**Reference: 0470861**

**Subject: Bonshaw Solar Farm (SSD 9438) – Clarification Letter**

Following the recent submission of the RTS and AR, on 8 April 2020 DPIE have requested further information on five (5) matters relating to the Project updates. These matters are outlined in **Table 2-1** below.

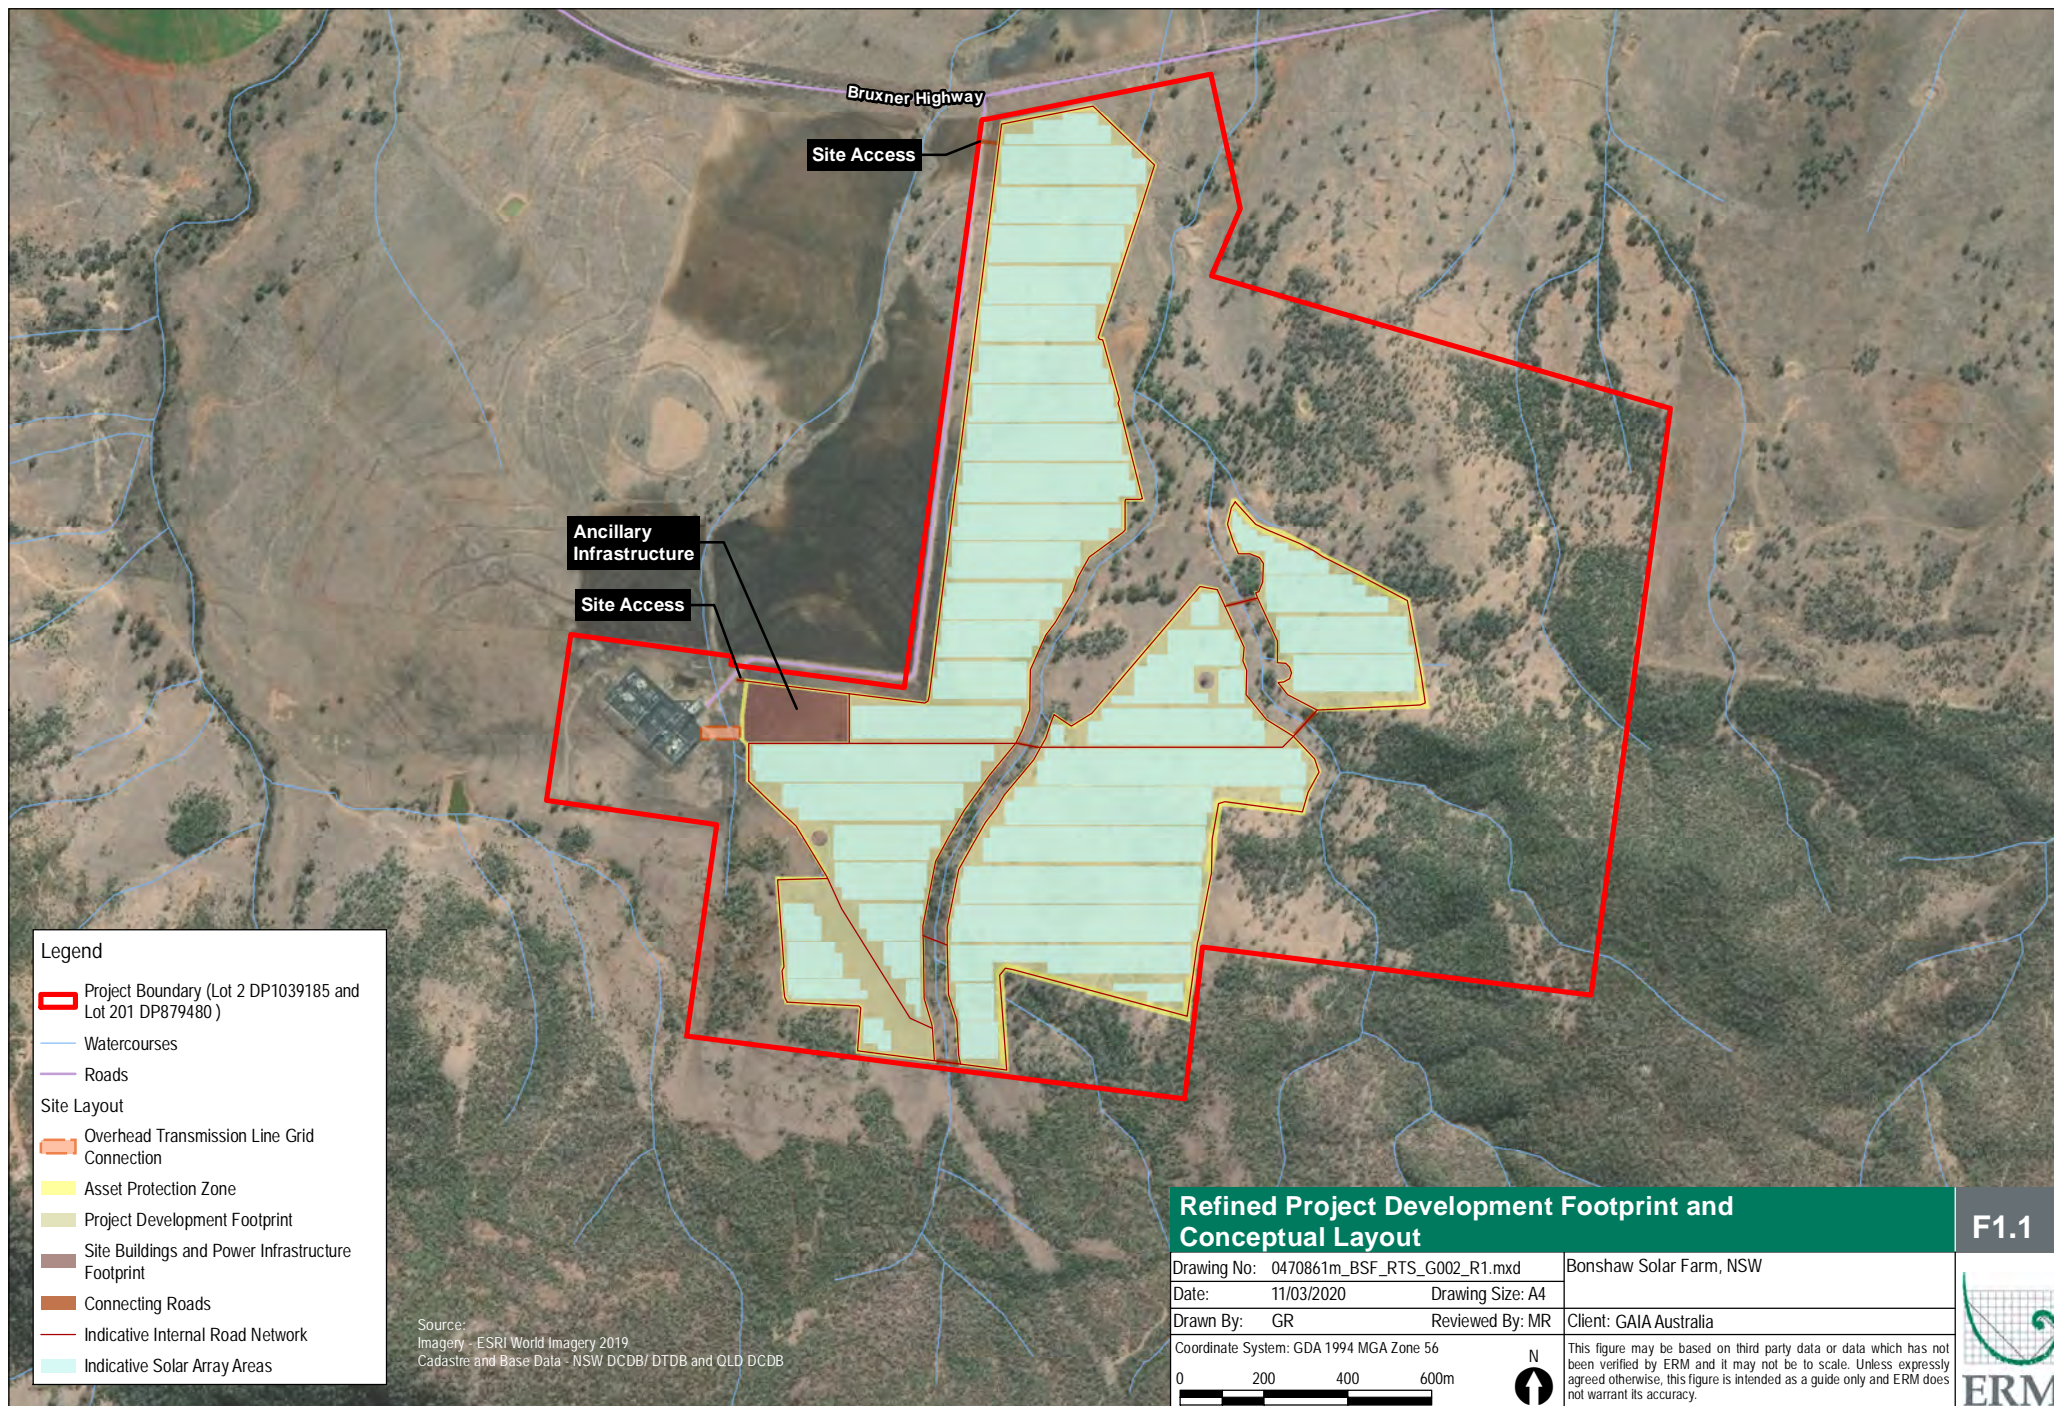
TransGrid made comment of the proposed method for obtaining approval for grid connection separately, noting that all works associated with the Project are to be included in the development approval for the Bonshaw Solar Farm. Consequently, an Amendment Report (AR) was prepared to provide details of the overhead connection.

Through the RTS and AR preparations, amendments to the Project footprint were made. The Project Area was extended from exclusively being Lot 2 DP 1039185, to include Lot 201 DP 879480 (Dumaresq Substation). The Development Footprint was also refined, being reduced from 167 hectares (ha) to 149.24 ha. The Project Area and Development Footprint, as updated, are shown in **Figure 1-1**.

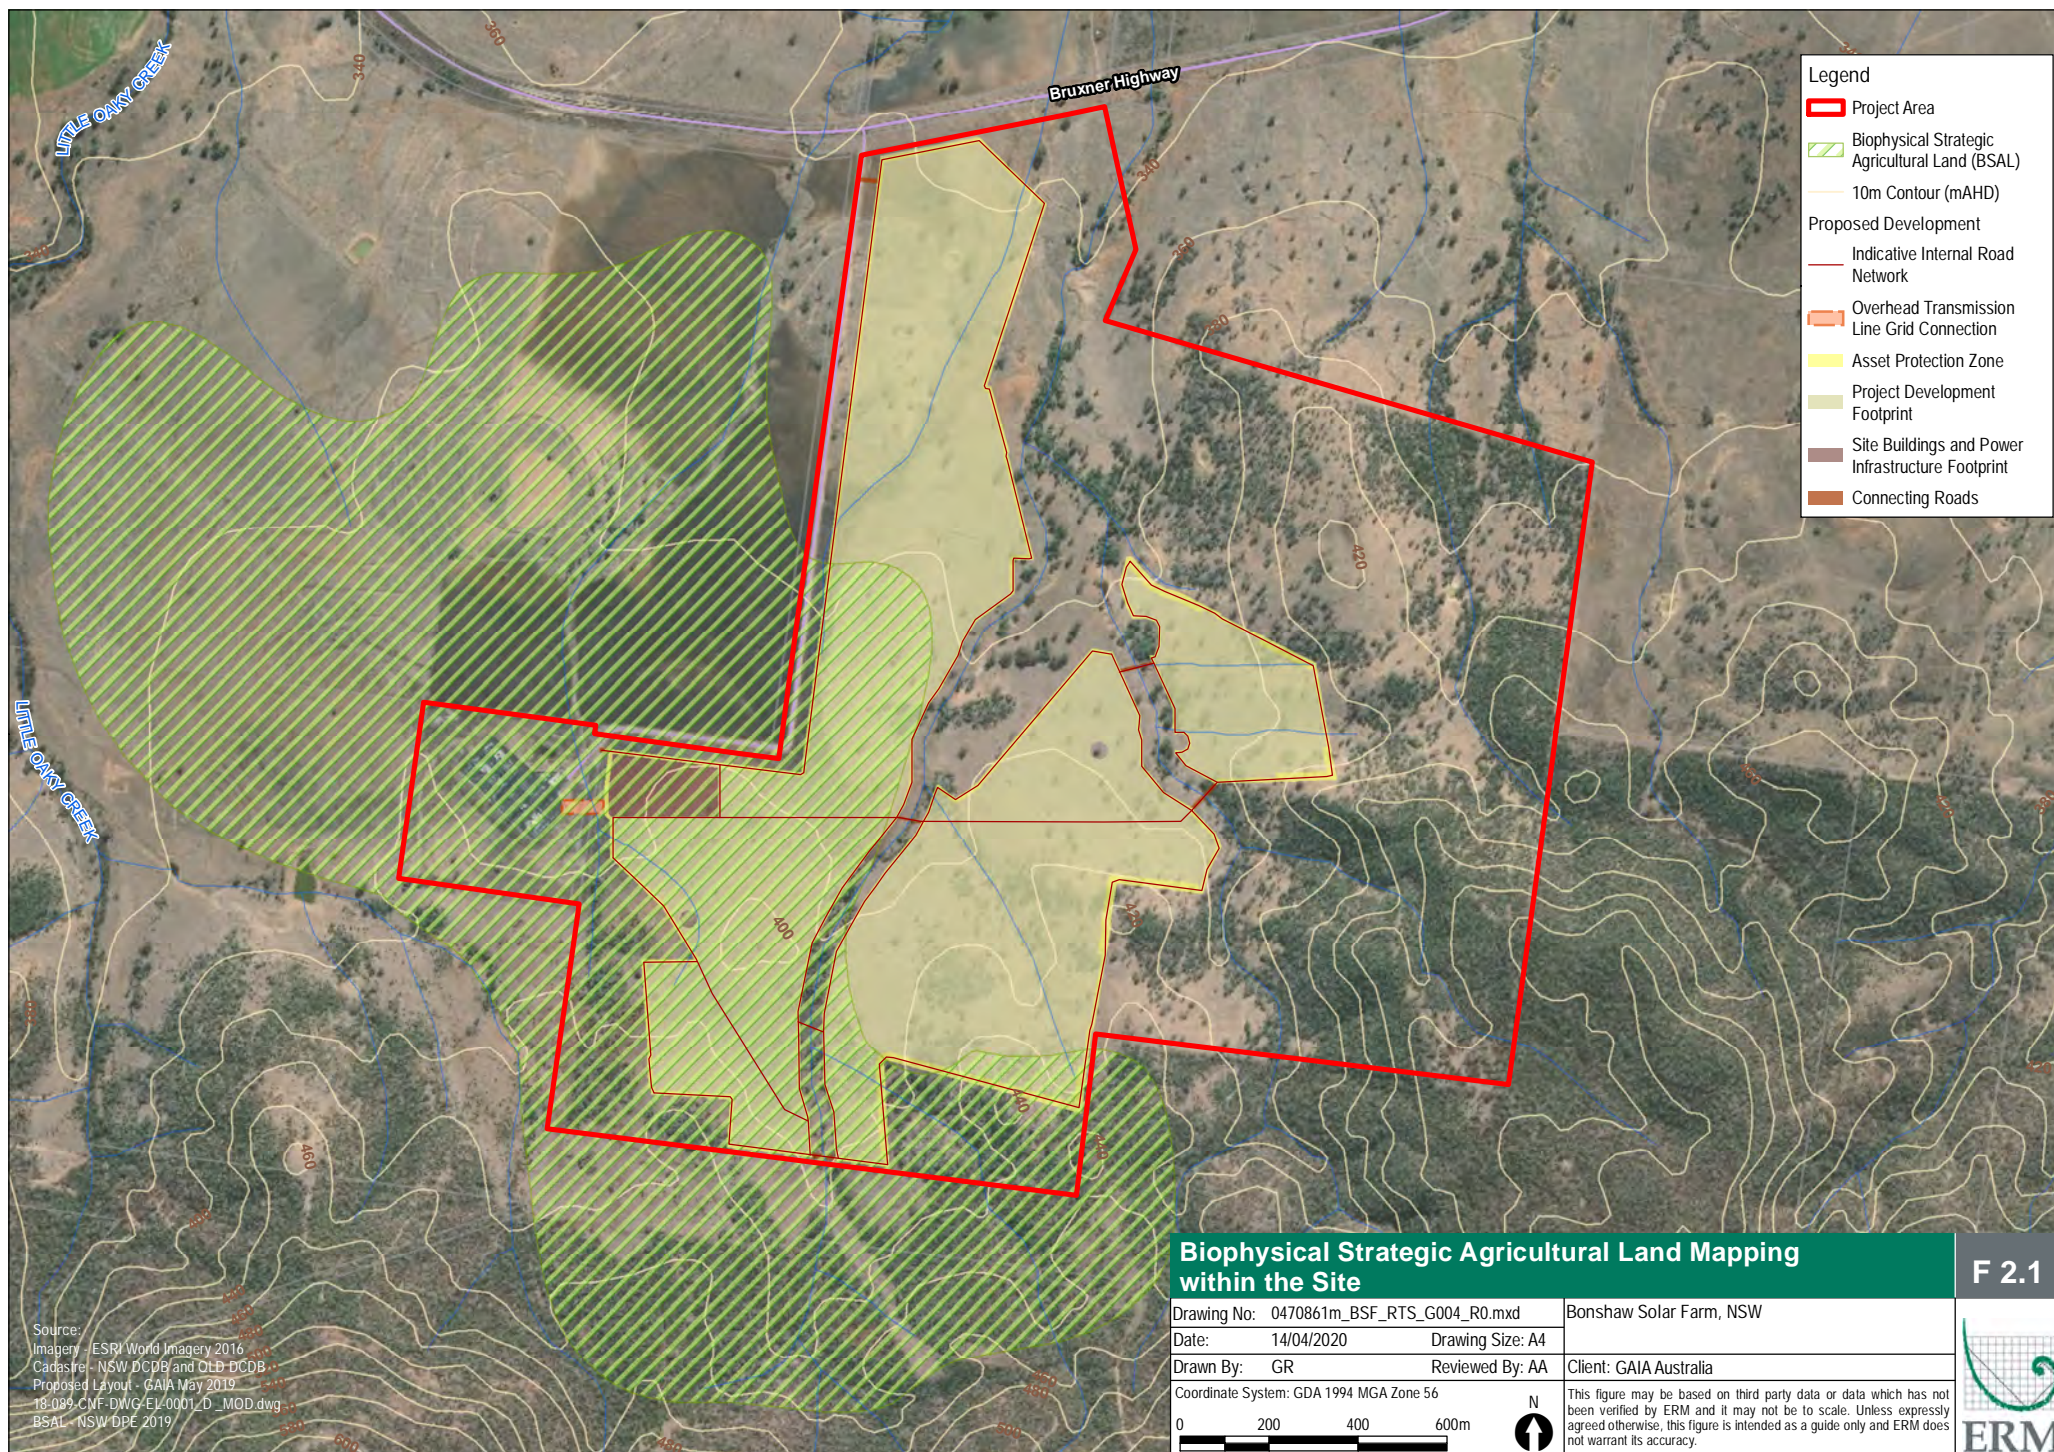
Item	DPIE Comments	Details
1	The development footprint has been reduced from 167 ha (EIS) to 149.24 ha (Submissions Report and Amendment Report), which means the footprint area was reduced about 11%. Please clarify what is the updated approximate number of solar panels and confirm the capacity (MW) of the project, as a result of the footprint reduction. Also please confirm if figures such as the project construction time or estimated employment would change as a result of project footprint area reduction.	<p>The reduction of the Development Footprint has affected these other aspects of the Project in the following ways:</p> <ul style="list-style-type: none"> <li>■ Approximate number of solar panels has decreased from 630,000 to 580,000;</li> <li>■ Review of the anticipated construction time has concluded that construction is expected to take approximately 18 months; and</li> <li>■ Employment estimations have been updated from being 190 full-time equivalent (FTE) to 180 FTE during peak construction, whilst operational employment estimations remain unchanged at 10 FTE.</li> </ul> <p>The capacity if the Project is expected to remain unchanged. It is anticipated that the 200 MW capacity will be able to be achieved through use of panels with high efficiency.</p>

Following the amendment of the Project through the RTS and AR process, the total area of BSAL within the Project Site and the Development Footprint has decreased to 54.43 ha (refer to **Figure 2-1**).

The Development Footprint encompasses 54.43 ha of BSAL, approximately 0.00002% of the total land area mapped as BSAL within NSW. The use of the BSAL mapped area will have limited impacts as the current use of the land for grazing can continue concurrently with the operation of the solar farm.

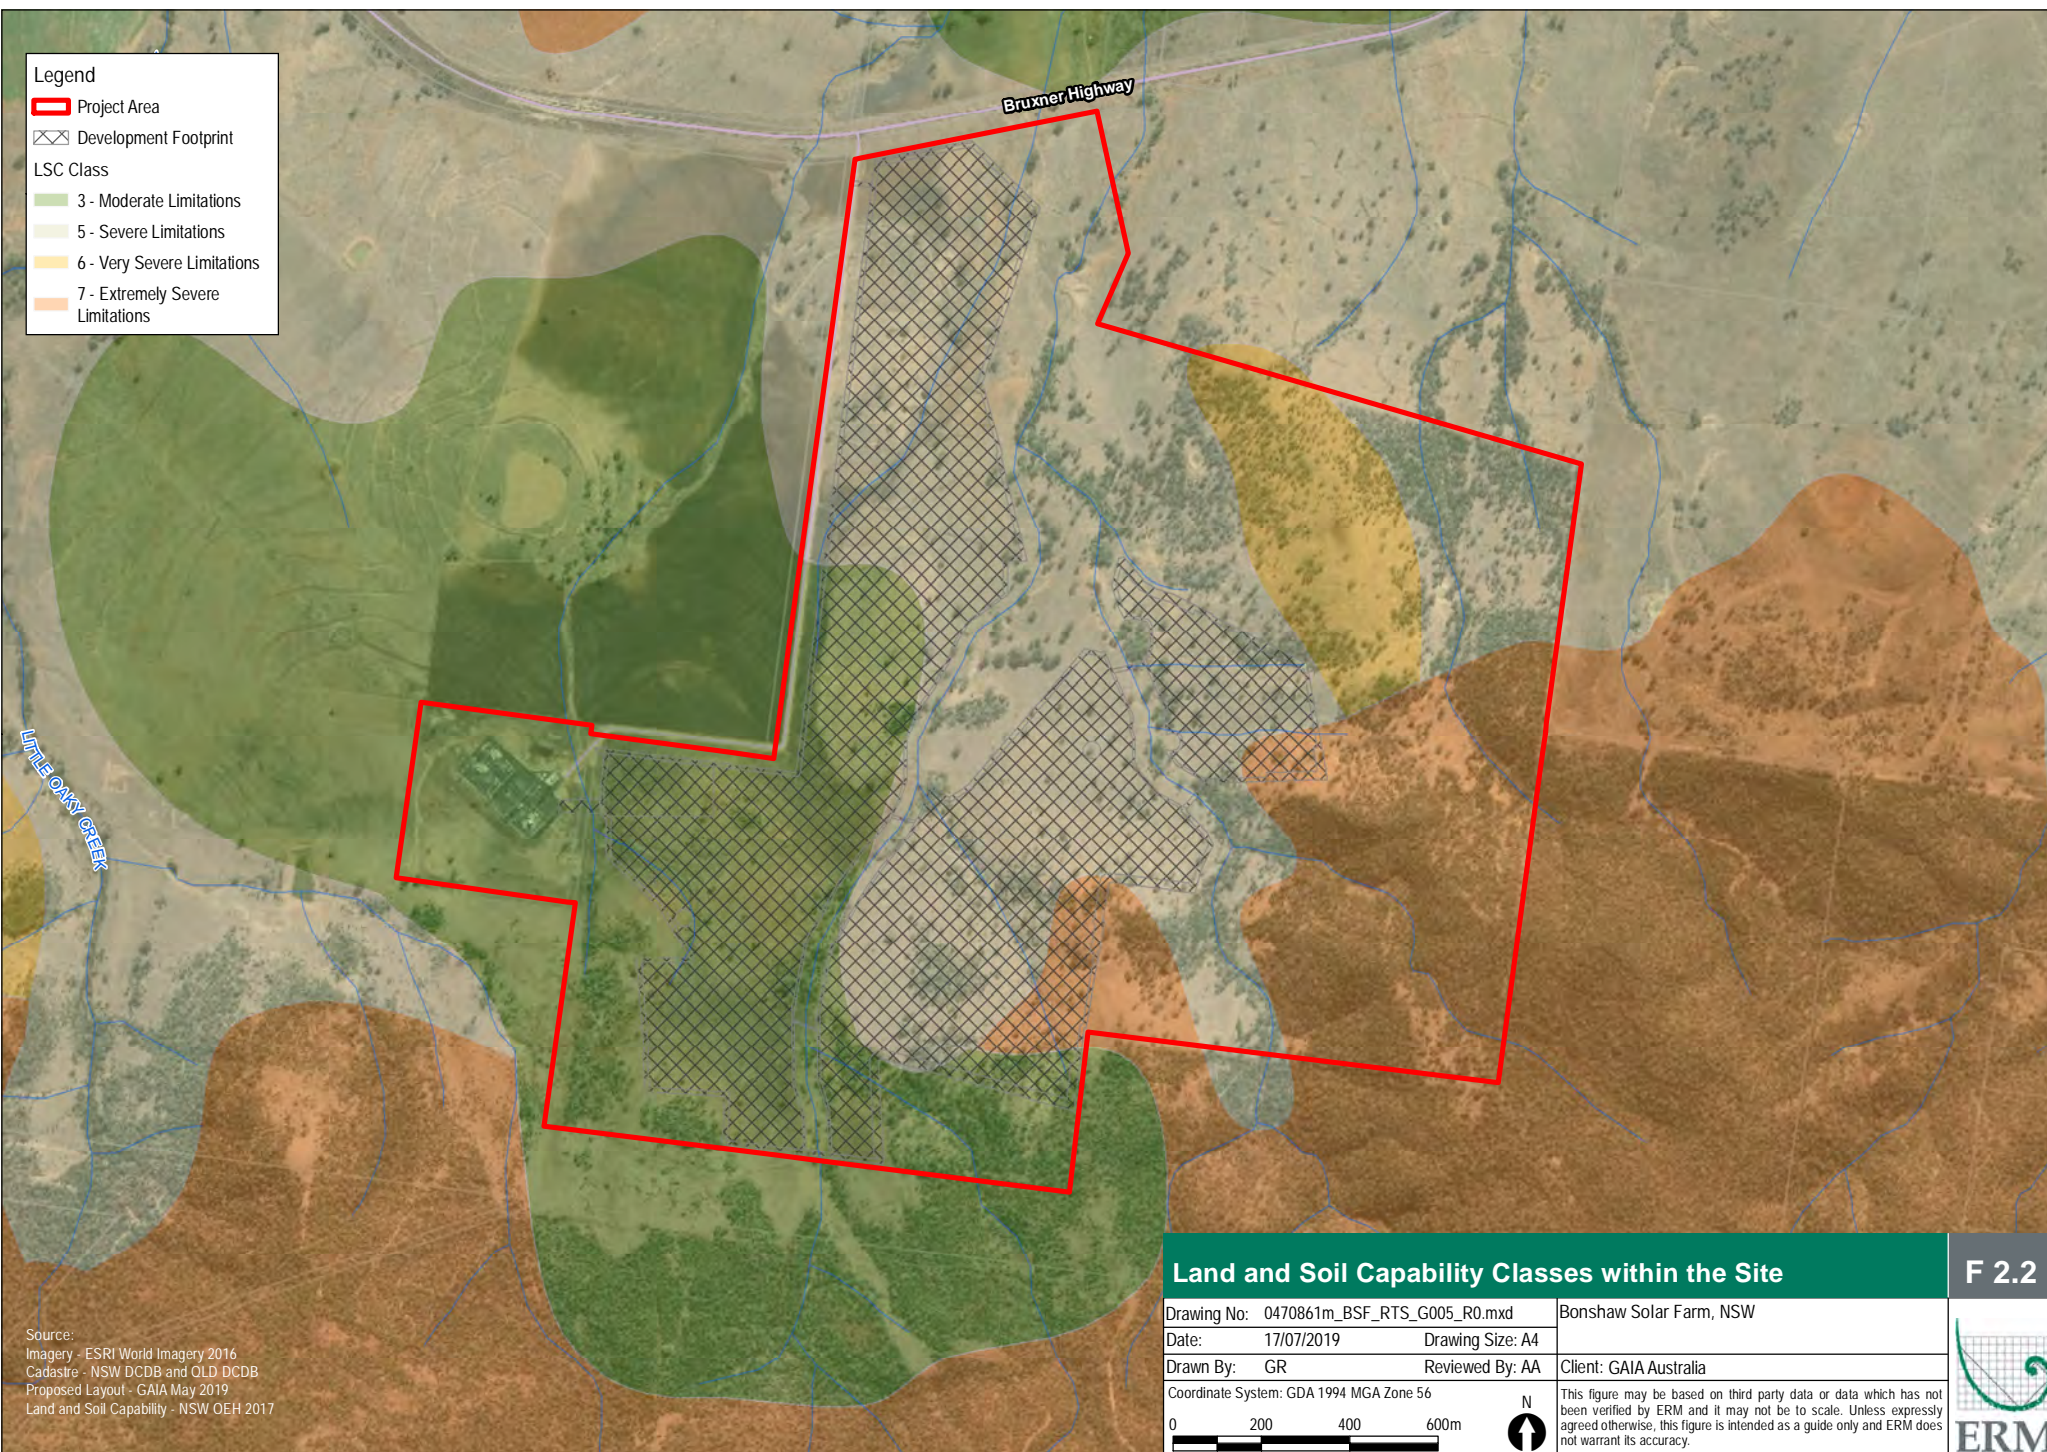
2	Confirm the capacity of the proposed battery storage (300 MW/XXX MW-hour).	The capacity of the Battery Energy Storage System (BESS) will remain unchanged, being 300 MW/MW-hour.
3	What is the distance between the proposed BESS and the existing TransGrid substation? The table 1-1 in the Preliminary Hazards Analysis (dated 20 March 2020) says N/A.	<p>The distance between the BESS and the Dumaresq Substation is approximately 200m.</p> <p>The implications of this is detailed in <b>Section 2-1</b> below.</p>
4	Clarify what is the area of mapped BSAL within the development footprint, as amended. Previous information provided stated 58.3 ha of BSAL.	<p>The amended Development Footprint has reduced the area of impacted BSAL to 54.43 ha.</p> <p>This is further detailed in <b>Section 2.2</b> below.</p>
5	The EIS (page 105) indicate that the project footprint would include Land and Soil Capability (LSC) classes 3 and 5 and includes a figure. Please provide the LSC classes locations for the amended footprint, and include percentages of proposed footprint areas for each LSC class.	<p>The amended Development Footprint will impact on LSC Classes 3, 5 and 7. The extent of impact has decreased.</p> <p>This is further detailed in <b>Section 2.3</b> below.</p>

**Figure 2-2** demonstrates the LSC classes within the Project. The LSC classifications across the Project Site range from:

- LSC Class 3 land of 54.43 ha, or approximately 36.5% of the total Development Footprint.
- LSC Class 5 land of 87.08 ha, or approximately 58.3% of the total Development Footprint.
- LSC Class 7 land of 7.76 ha, or approximately 5.2% of the total Development Footprint.

The land classifications are not restrictive to the construction and operation of a solar farm. Grazing can still be undertaken concurrently with the solar farm operation. Grazing suits the land classification and will be undertaken concurrently with the solar farm by managed vegetation heights under the panels.
